LICENSE AUTHORITY FILE COPY  
UNITED STATES  
NUCLEAR REGULATORY COMMISSION  
WASHINGTON, D. C. 20555

January 30, 1984

The Commission has issued the enclosed Amendments Nos. 126, 126, and 123 to Licenses Nos. DPR-38, DPR-47 and DPR-55 for the Oconee Nuclear Station, Units Nos. 1, 2 and 3. These amendments consist of changes to the Station's common Technical Specifications (TSs) in response to your request dated September 14, 1983.

These amendments revise the TSs to correct the values for the Axial Power Shaping Rod (APSR) Position Limits after 385 EFPD for the Unit 3 Cycle 7 of operation.

APSR POSITION LIMITS  
 AFTER 385 <sup>+0</sup><sub>-10</sub> EFPD  
 UNIT 3  
 OCONEE NUCLEAR STATION  
 Figure 3.5.2-4C3

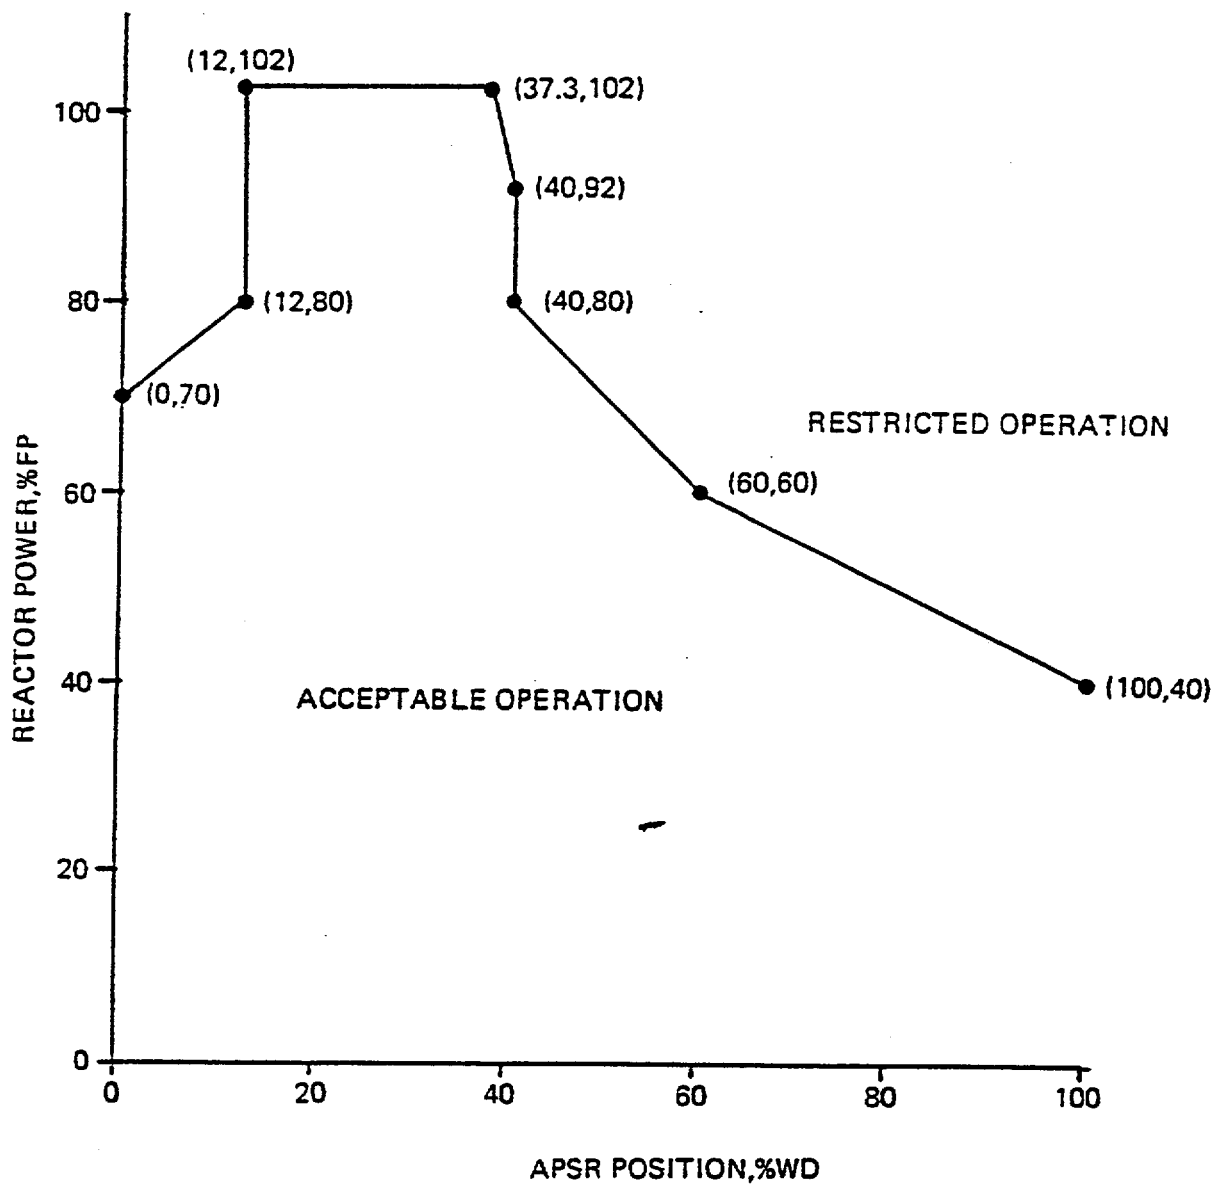
In a submittal dated September 14, 1983, DPC disclosed that while calculating the Oconee Unit 2 Cycle 7 TSs, they became aware that a correction should be made to the APSR position limits of Unit 3 after 385 Effective Full Power Days (EFPD). Review and evaluation of the Oconee Unit 3 TS change was requested along with the Oconee Unit 2 Cycle 7 reload review and evaluation. The Unit 2 Cycle 7 reload TSs, including the APSR position limits for Unit 2 Cycle 7 and the corrected APSR position limits for Unit 3 Cycle 7, were subsequently reviewed and found acceptable. By letter dated November 23, 1983, the Commission issued Amendments Nos. 124, 124 and 121 revising the TSs to allow full power operation of Oconee Unit 2 during fuel Cycle 7, but for administrative reasons, deferred the issuance of the Unit 3 Cycle 7 corrected APSR position limits to a later date as a separate licensing action. This evaluation addresses the deferred Unit 3 Cycle 7 corrected APSR position limits.

The difference in the APSR position limit was caused by poor convergence of the calculated power distribution for Oconee Unit 3 Cycle 7. The discrepancy was discovered at the time of the preparation of the Oconee Unit 2 Cycle 7 reload but before Oconee Unit 3 reached 385 EFPD. Therefore, no period of potentially unsafe operation occurred. The appropriate report was filed.

Inasmuch as the calculation was carried out with an approved method and the recommended number of iterations was used, we find the requested TS change acceptable for Oconee Unit 3.
